CAP Meeting Agenda

ITEM 5.1

DEVELOPMENT APPLICATION – 24033919 – 5 REGENT STREET, MILLSWOOD

DEVELOPMENT NUMBER:	24033919
APPLICANT:	Alice Adamson
ADDRESS:	5 REGENT STREET MILLSWOOD SA 5034
NATURE OF DEVELOPMENT:	Carport
RELEVANT AUTHORITY:	Council Assessment Panel
CATEGORY OF DEVELOPMENT:	Review of a Decision by the Assessment Manager (Code Assessed – Performance Assessed)
RECOMMENDING OFFICER:	Assessment Manager
ATTACHMENTS:	Attachment 1: Application plans and reports (including a report from Tertiary Tree Consulting Pty Ltd) Attachment 2: Delegated assessment report Attachment 3: Council’s consultant arborist report Attachment 4: Decision notification form Attachment 5: Application for review and accompanying letter Attachment 6: Delegated assessment report – DA 23030316 Attachment 7: Pruning recommendation and correspondence – DA 23030316

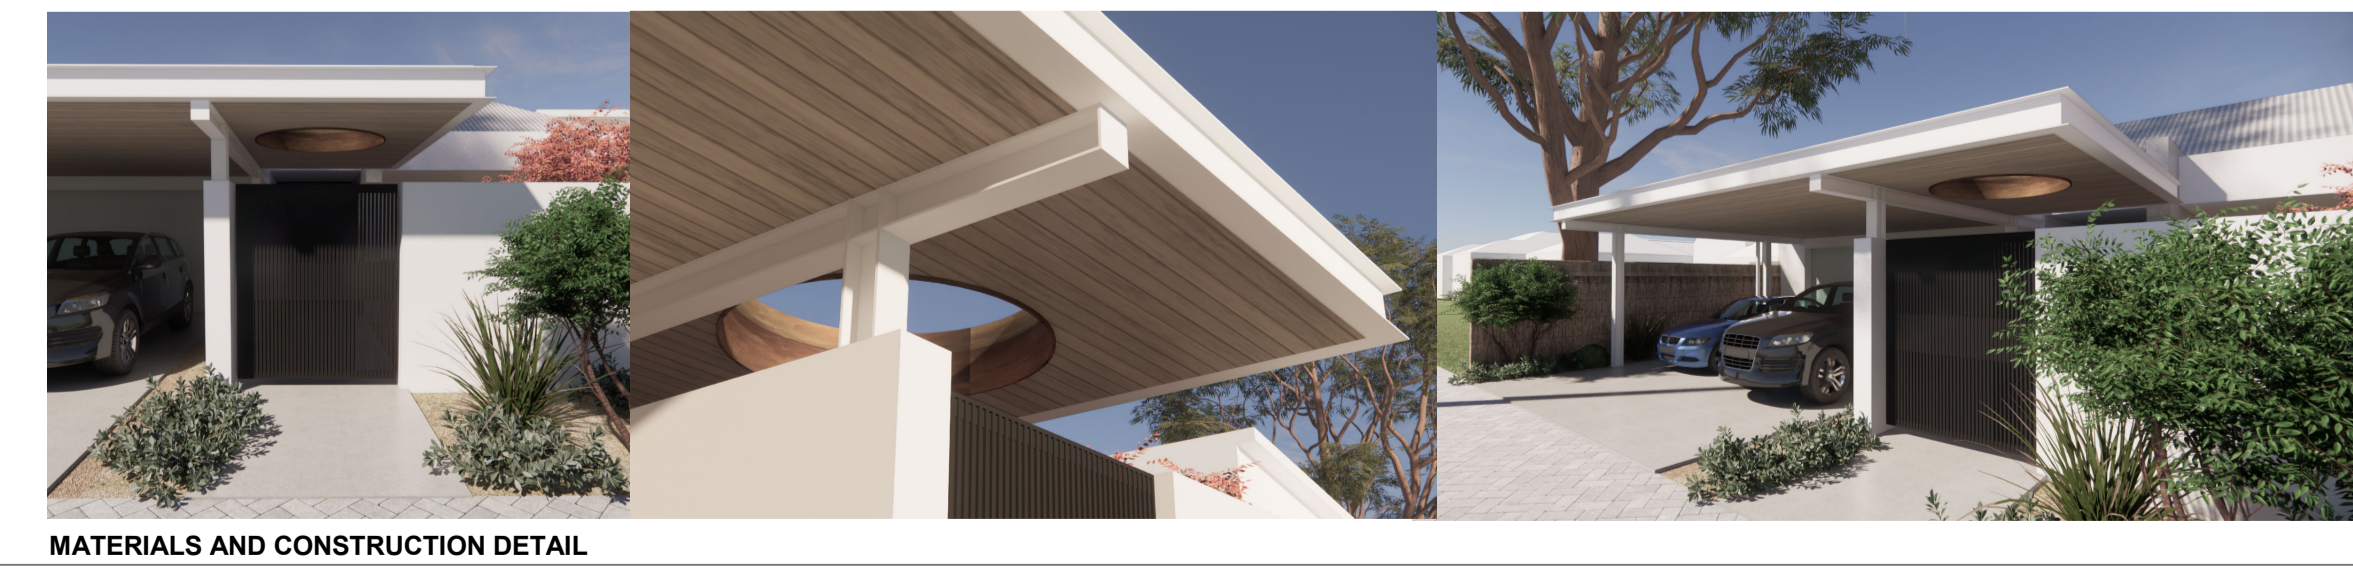
- Minimising visual bulk:** The roof has been designed to be as thin as possible - minimising any bulky form beyond the front of the main house, and allowing the form of the main house to maintain its presence and position in the overall streetscape. See Diagram 1 'before' and 'after'.

- Maintaining sightlines and sense of open space:** The carport is open on all sides and columns are set back from the front edge, which gives clear visibility through and past the structure, maintaining continuous lines of sight from street level to beyond the site, maintaining the existing sense of streetscape space and form. See Diagram 2 'street view'.

SITE PLAN

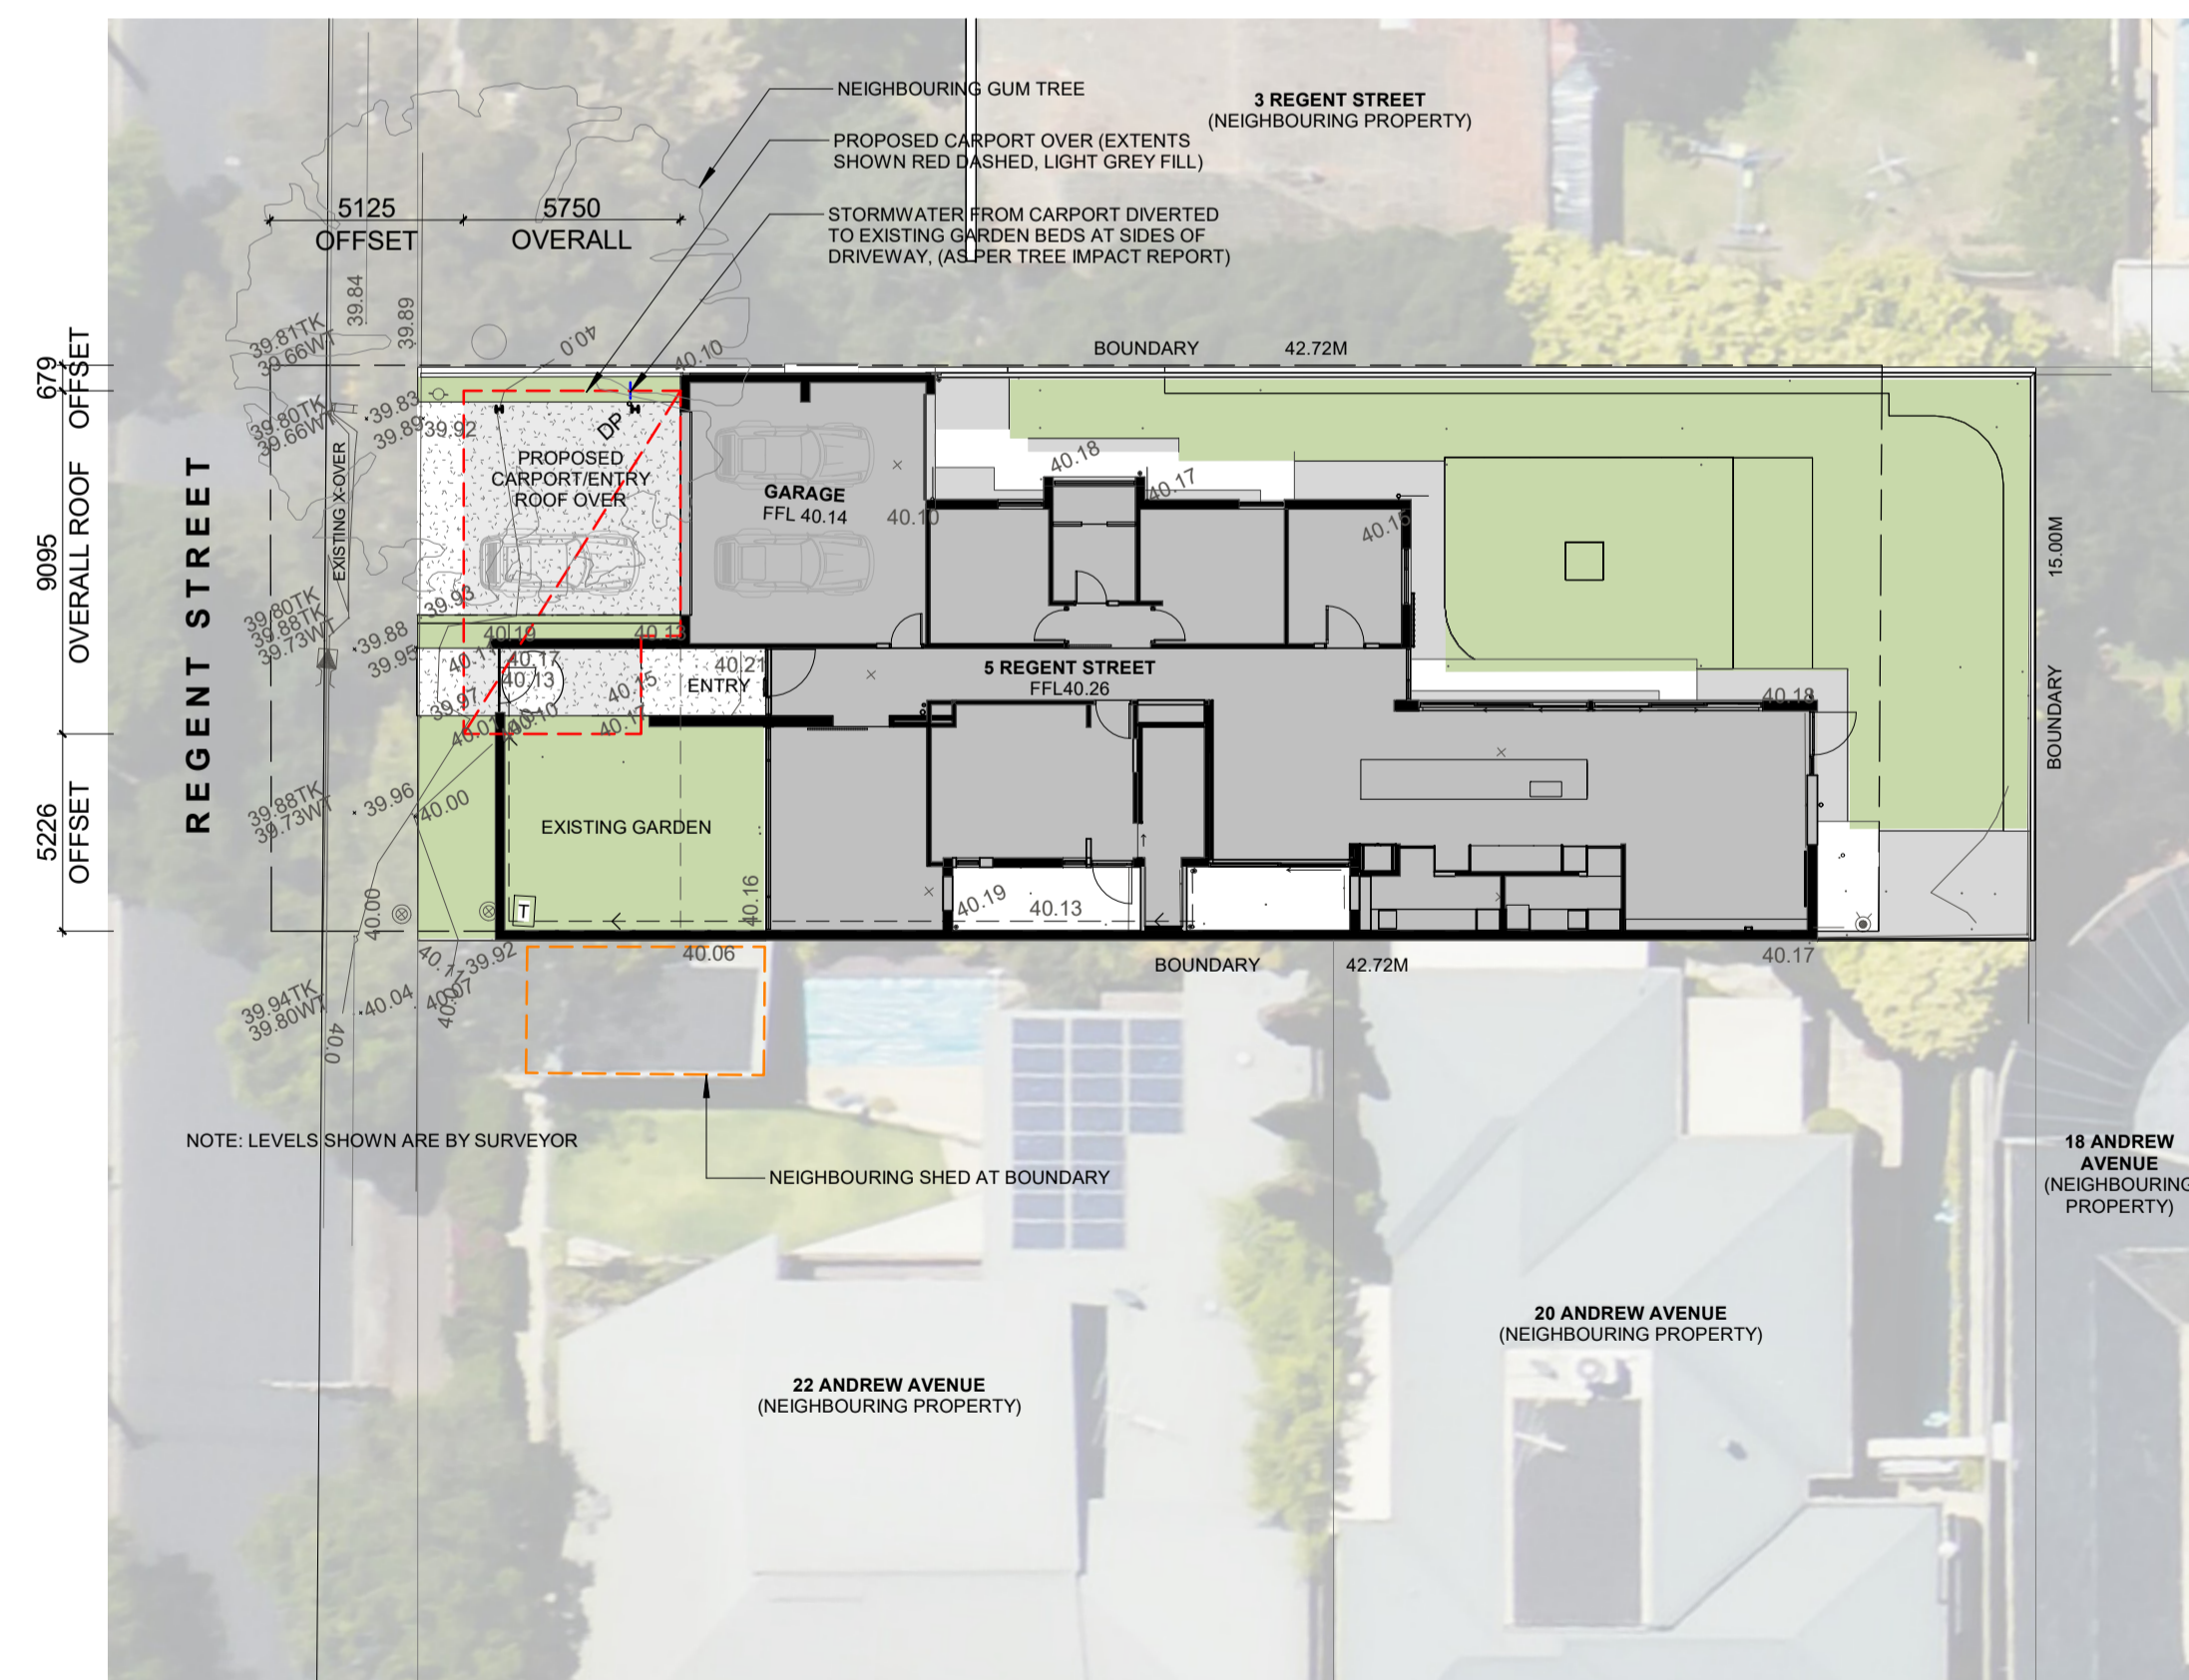
- The proposed combined carport and canopy is sited forward of the building line and would be the visually dominant feature of the dwelling, failing PO 4.2 of the Historic Area Overlay and PO 10.1 of the Established Neighbourhood Zone.
- The proposed combined carport and canopy has an insufficient setback from the primary street and is not in keeping with the character of the locality, failing PO 1.1 and PO 4.1 of the Historic Area Overlay; PO 11.1 of the Established Neighbourhood Zone; and PO 20.1 of Design in Urban Areas.

The proposed carport is effectively the same as proposed in DA 24009737, with the only noticeable change being a slight reduction in the height of the fascia.

The flat roof form and white render of the proposed carport is in keeping with the style of the existing dwelling but fails to complement the character of the area. As discussed above, the character of the area is a mixture of contemporary and character dwellings with any ancillary development recessed from the building line of dwellings. There are examples of garages forward of the dwelling in Regent Street. However, they are located outside of the locality, approved under previous legislation, would fail to satisfy the provisions of the Planning and
